ADDENDUM

ADDENDUM NO.: 03
PROJECT NAME: WPA Street Reconstruction (E 109th St., S Hoyne Ave., S Harding Ave., E 102nd St.)
PROJECT NO.: 22312, 22313, 22314, and 22329
CONTRACT NO.: C1616
DATE OF ISSUE: December 2, 2024

NOTICE OF CHANGES, MODIFICATIONS, OR CLARIFICATIONS TO CONTRACT DOCUMENTS

F.A. RTE.	SECTION	COUNTY	TOTAL SHEETS	SHEET NO.
			31	31A
CONTRACT NO. C1616				
ILLINOIS FED. AID PROJECT

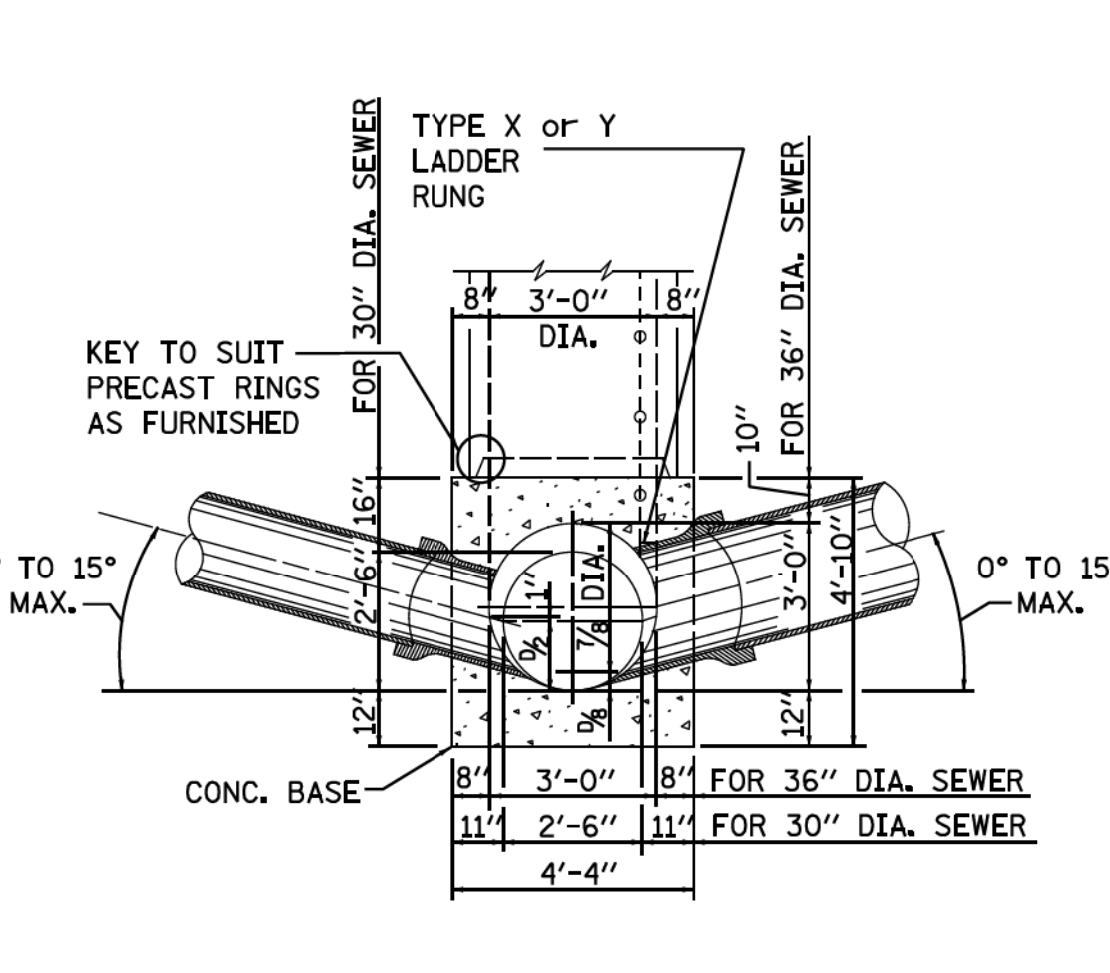
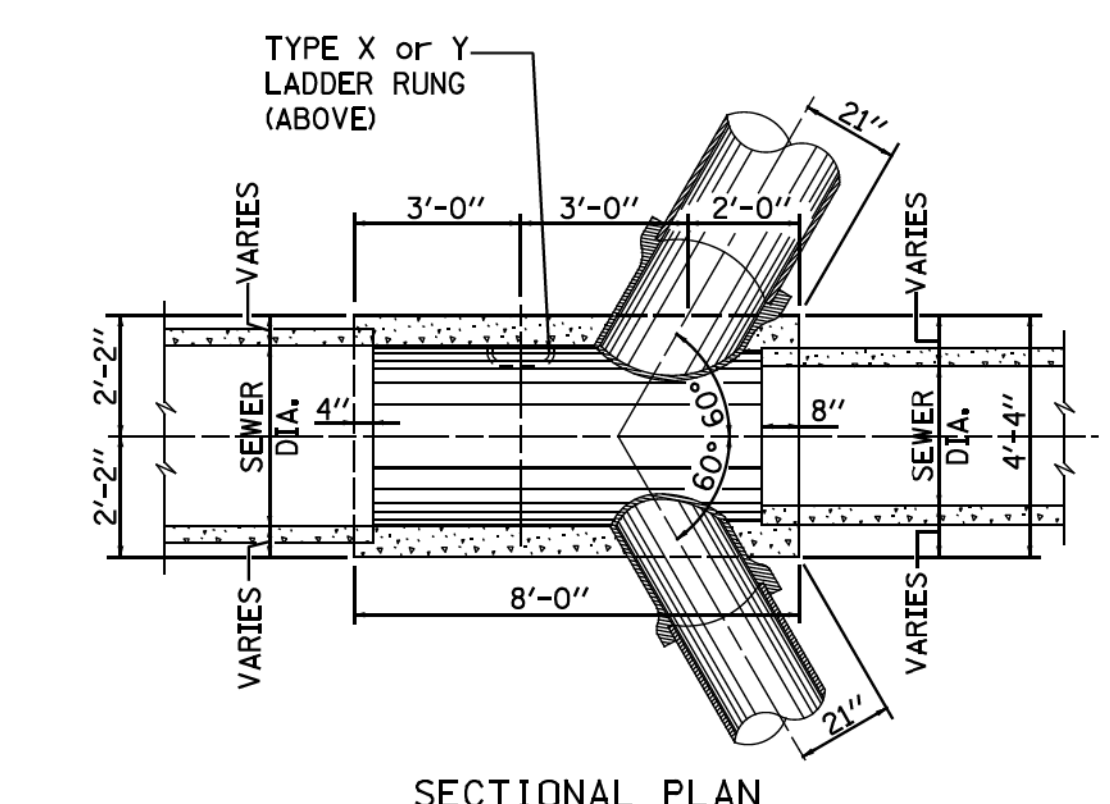
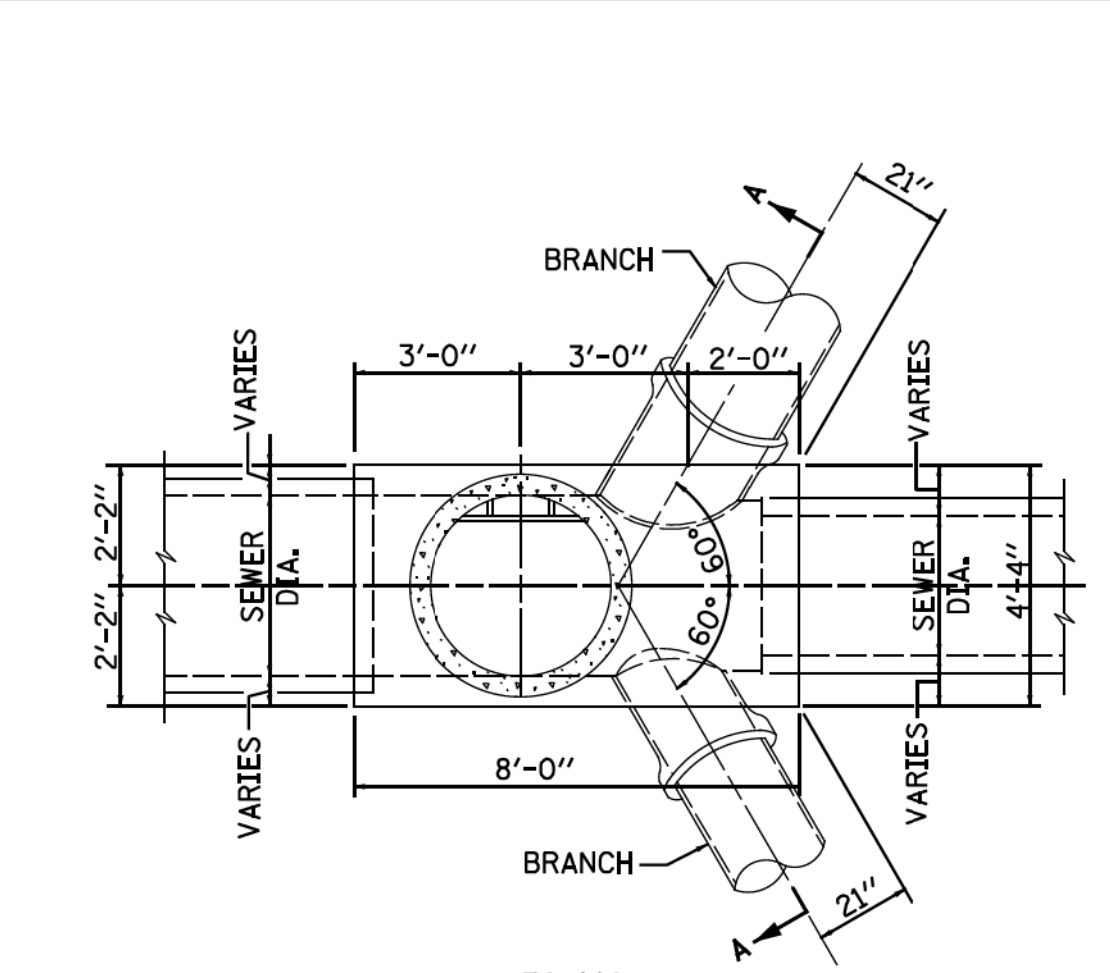
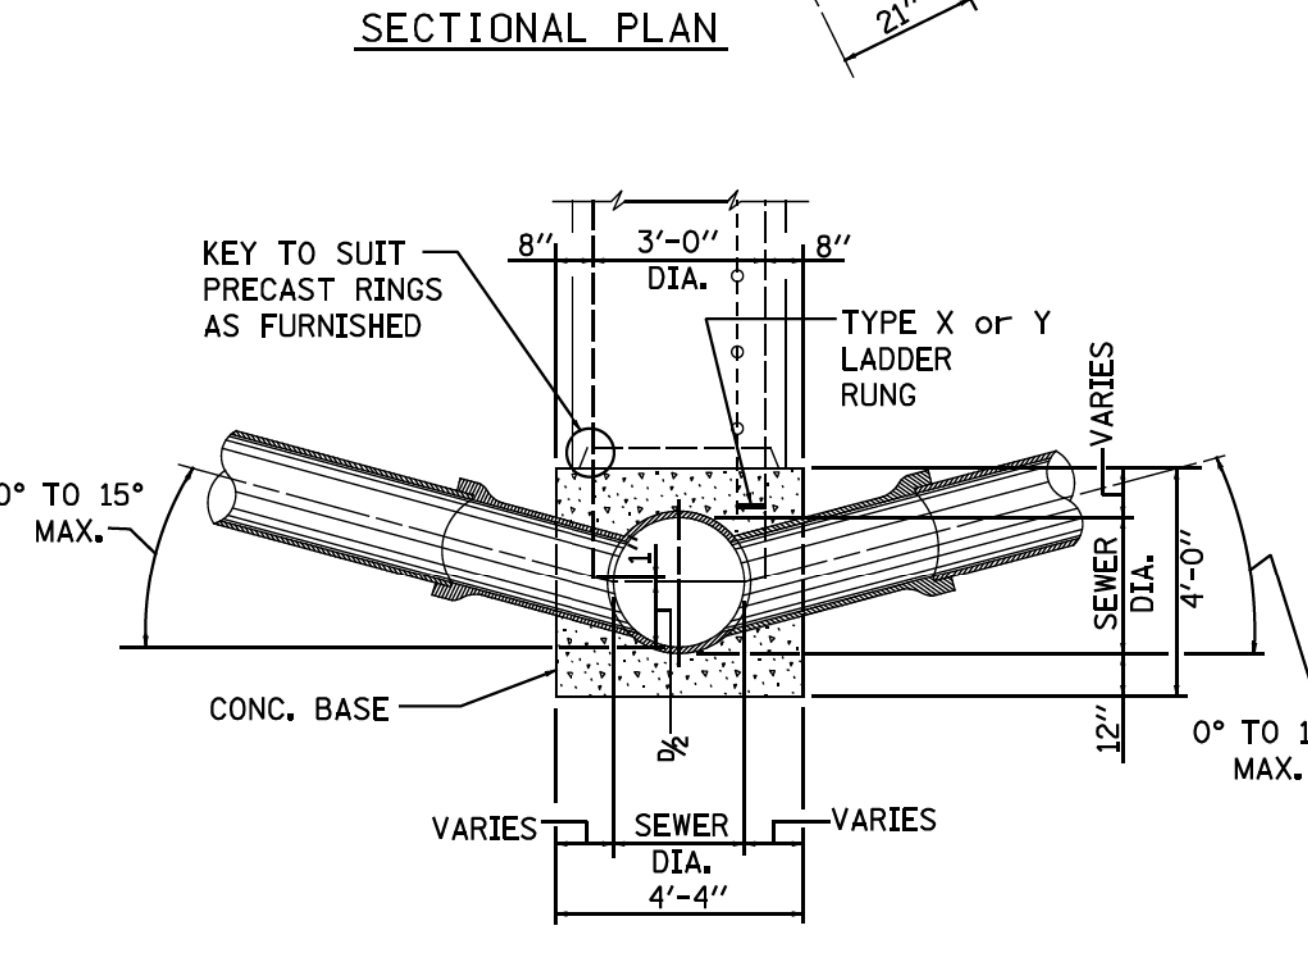
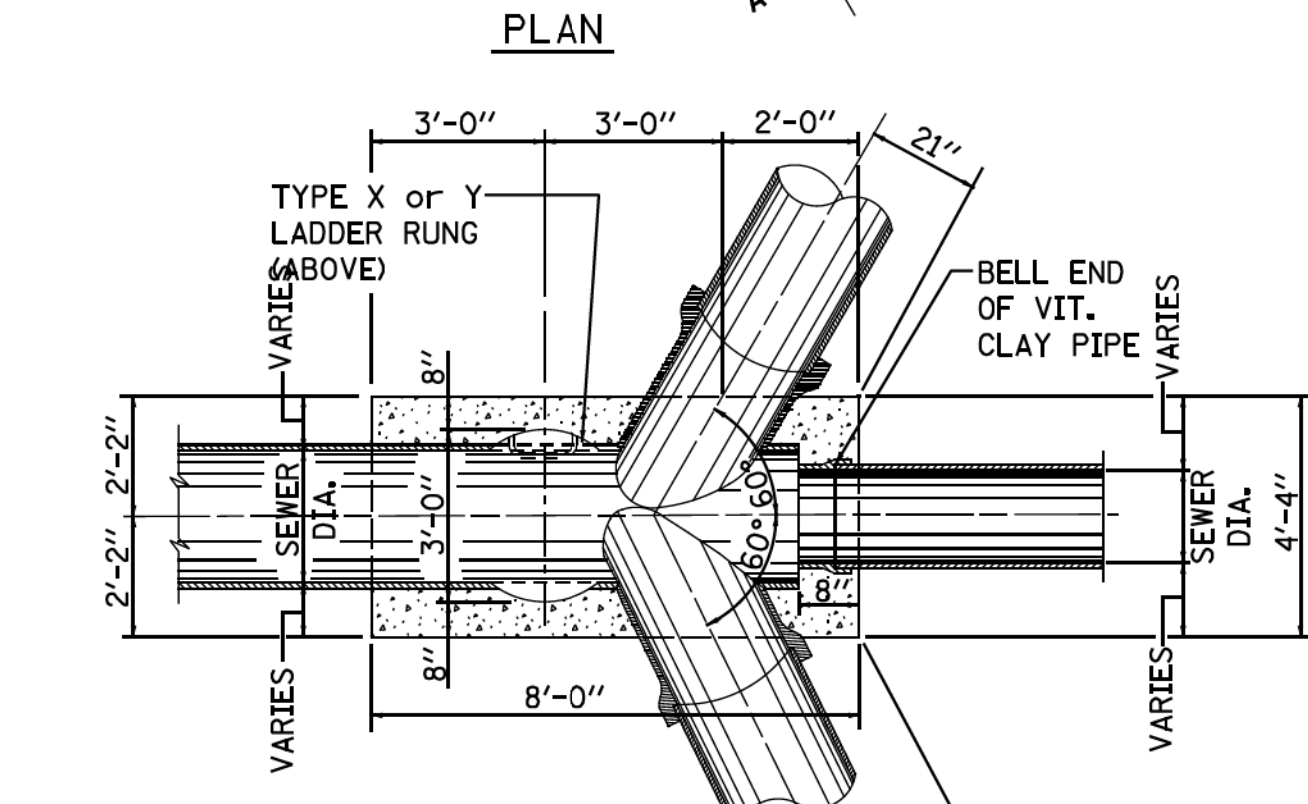
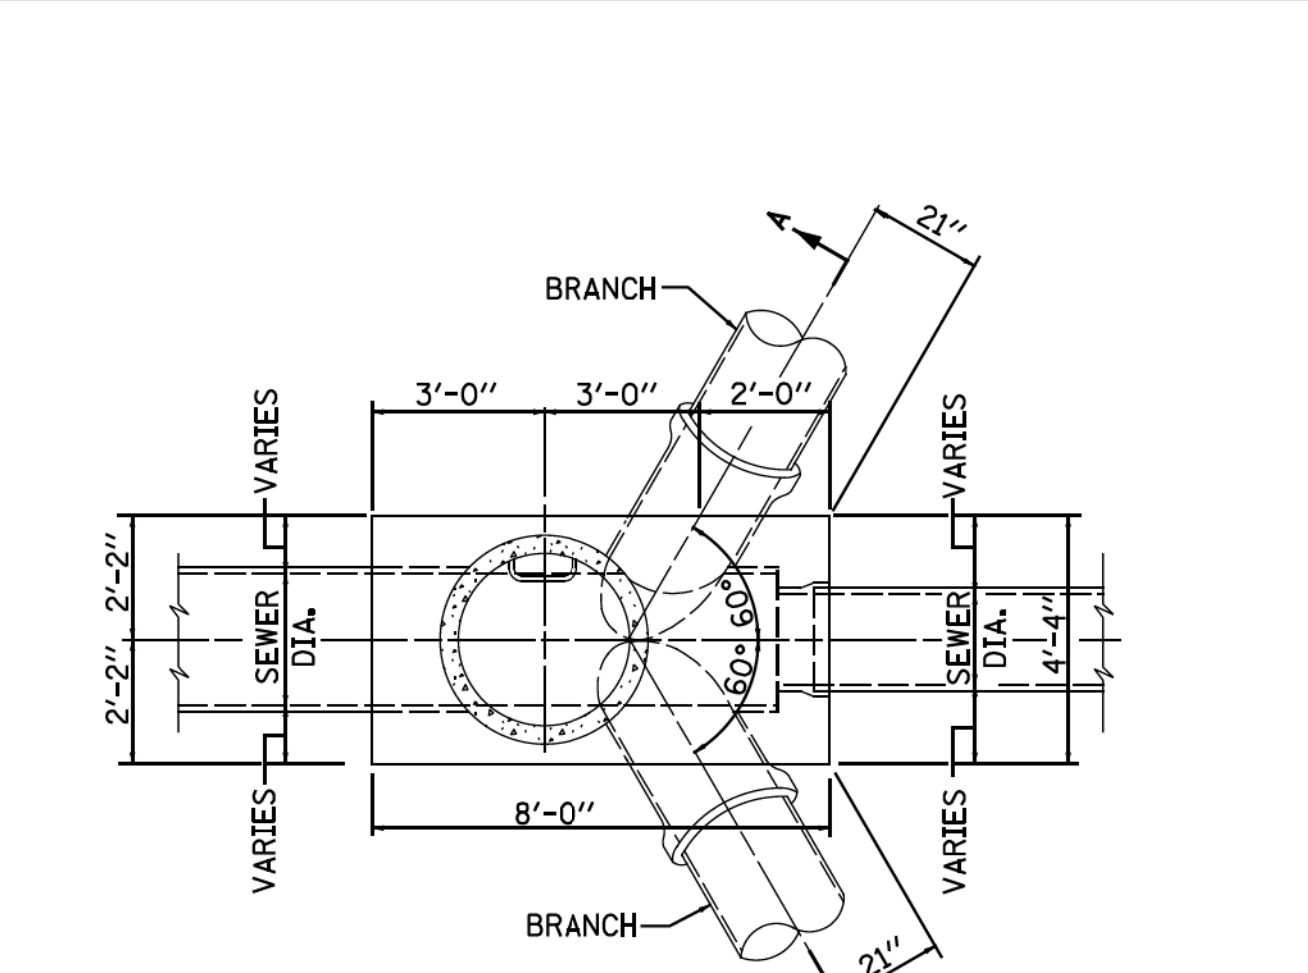
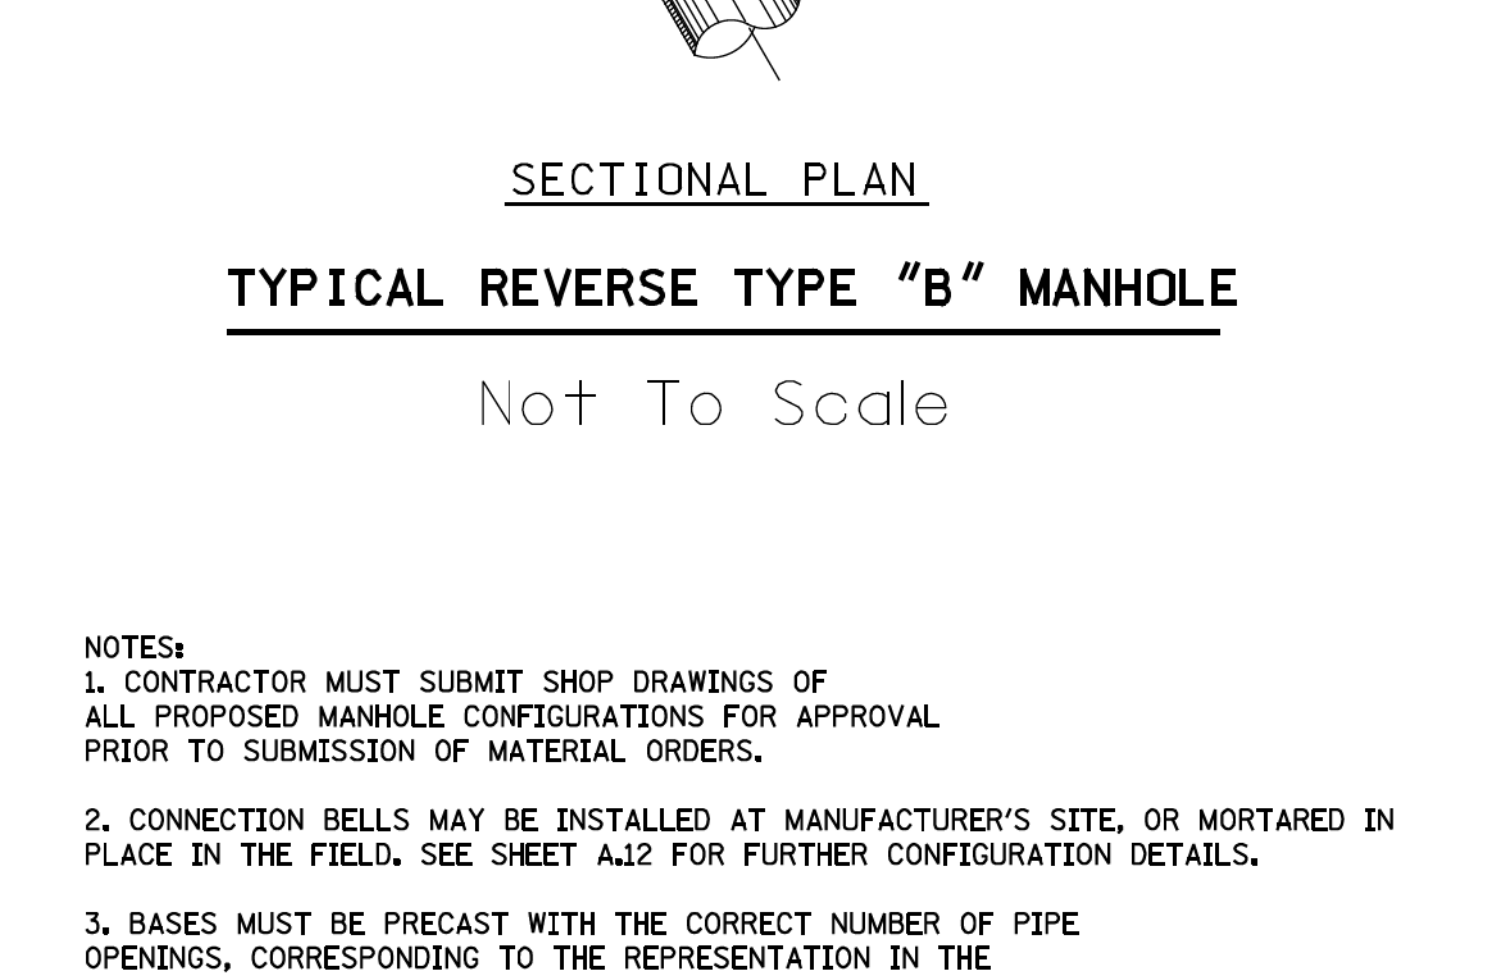
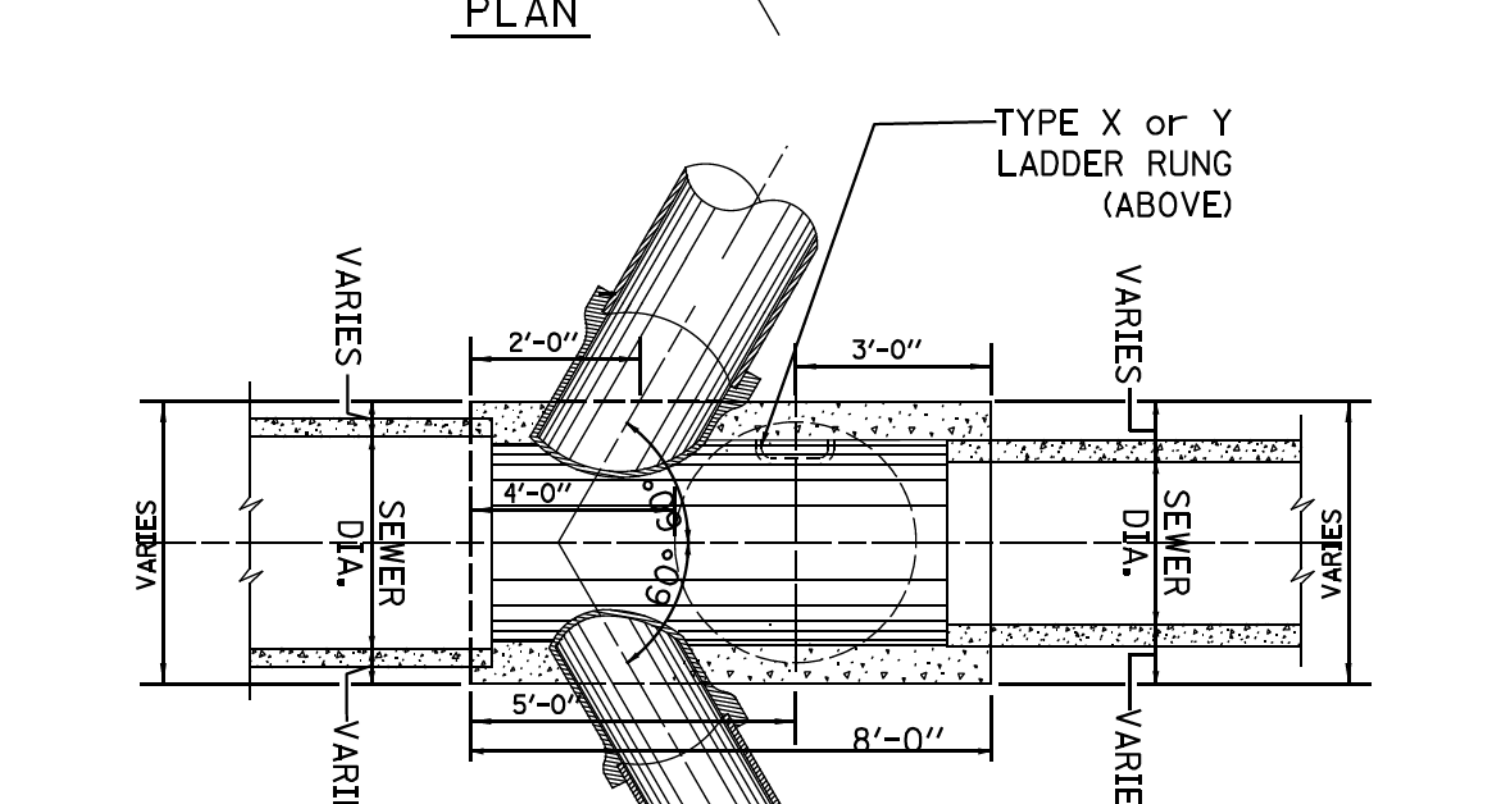
Change 3 ADD SHEET 31A CDWM Sewer Detail for E. 102nd
